## Review Memo

TO: LEED Review Team  
FROM: Mallory Karch, LEED Project Coordinator  
DATE: 5/1/2014  
PROJECT NAME: StopWaste.org  
PROJECT ID: 10814498  
**SUBJECT:** Response to Review Comment: Indoor Environmental Quality  
Credit Daylight and Quality Views

**Figure 1 - Distance between project building and brick wall**

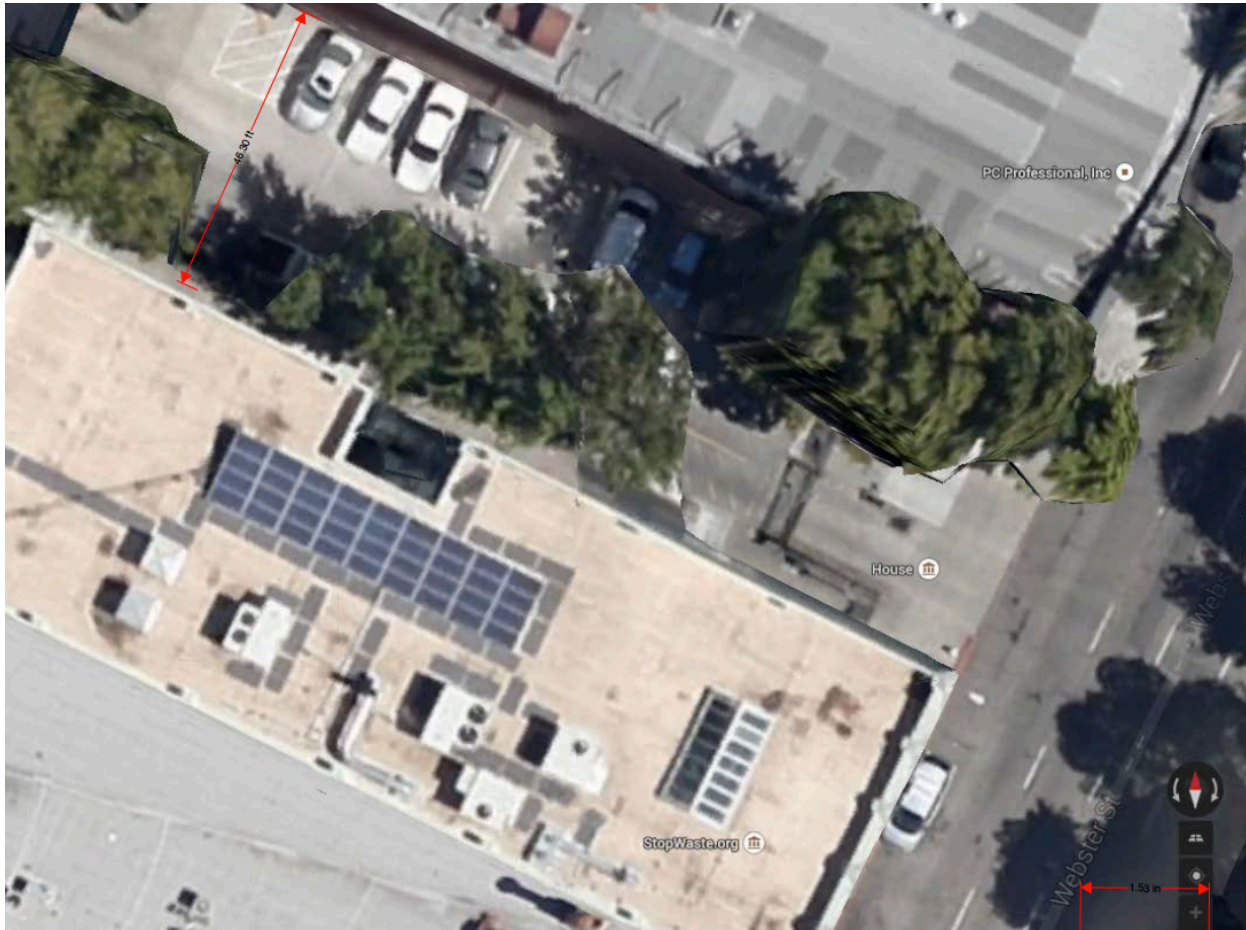
Note that the view quality is unclear for certain spaces. The downstairs cubicle area appears to include a view to a brick wall, which may not meet the requirements of View Type 2 or 3. Generally views through doorways with solid doors do not count. In addition, it is unclear whether the view to a window across the building meets the view quality criteria because there are a number of obstacles blocking the view.

In one of the photographs does indeed show that a brick building is included in the view. It is approximately 46 feet away from the project building. The space in between the project building and its neighboring building include vegetation such as trees, a parking lot with moving people and vehicles, the sky and other such regular city activities. These other features as well as the relative distance from the project building are indicated in the Google Earth image shown below (Figure 1). (this image has also been uploaded under file name "StopWaste.org\_IEQc5\_Views\_Figure1.pdf). The office/cubicle that may be in question is a ground floor space, approximately 30 feet from the front corner of the project building. The project team is confident that this image demonstrates compliance for this space. Conservatively, if this space were not compliant, credit compliance would not be effected by removing the space from

the calculations, as views are available to nearly all of the project buildings occupants with multiple view types without question.
